Preliminary Plans Approved:
JDB
12/3/15

PRELIMINARY PLANS

| NO. | DATE | REVISION | BY |
|--|-----------|-------------------|--------------|
| STRUCTURE B-40-285-27H | | | |
| IH 94 EB/IH 43 SB OVER LAND | | | |

TYPICAL SECTION
(LOOKING NORTH)

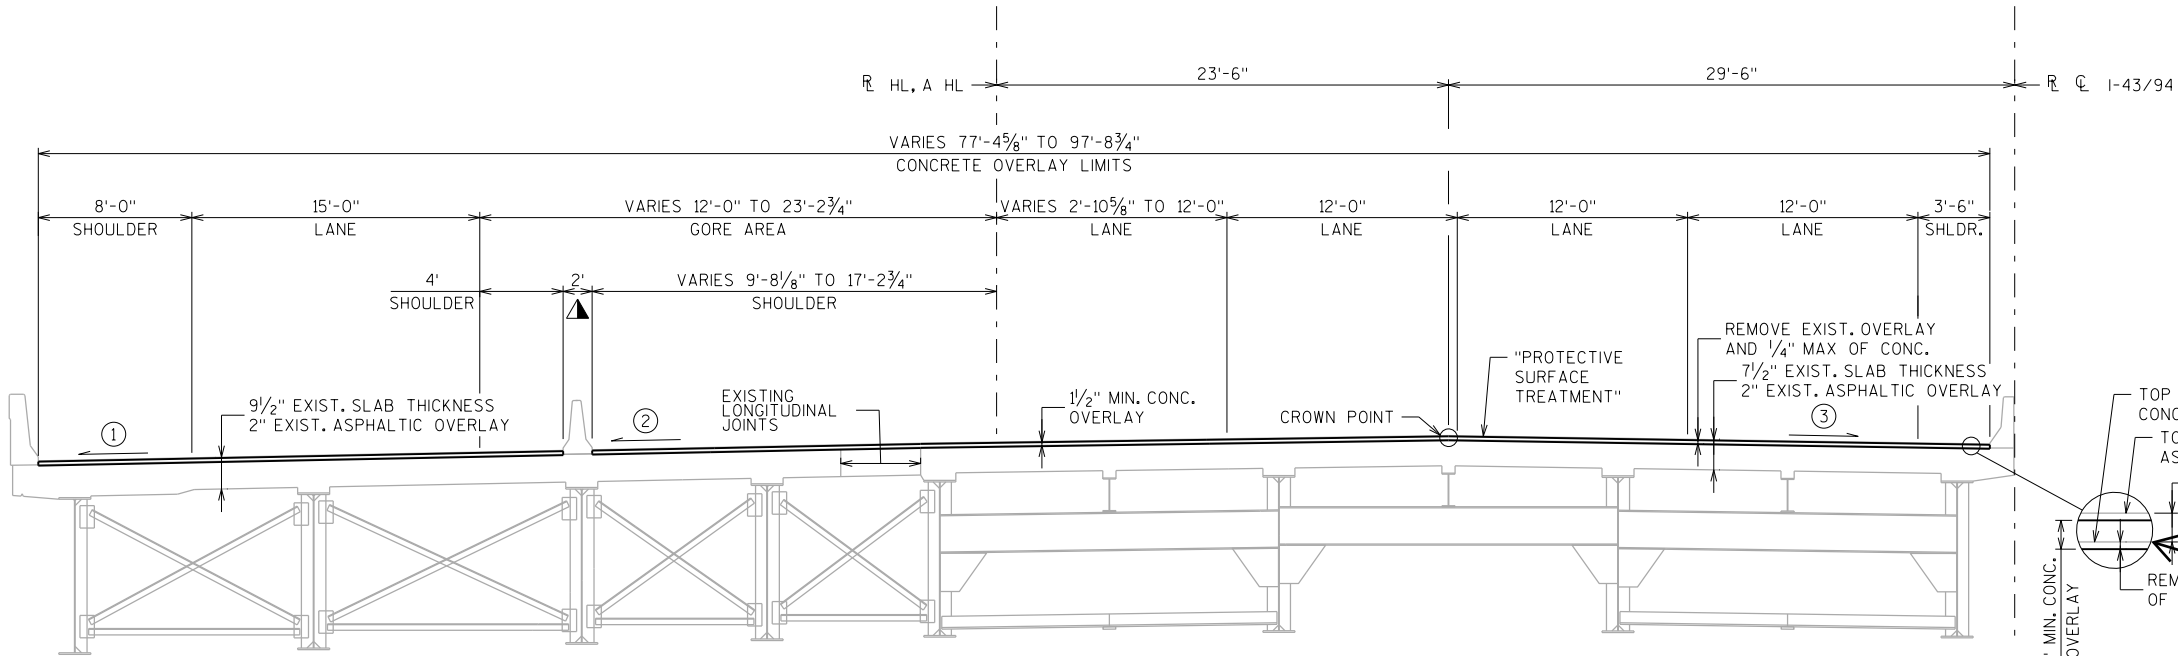
Include girder size / spacing
on typical section drawings

Sheet membrane
waterproofing layer
between asphaltic
overlay and concrete
deck
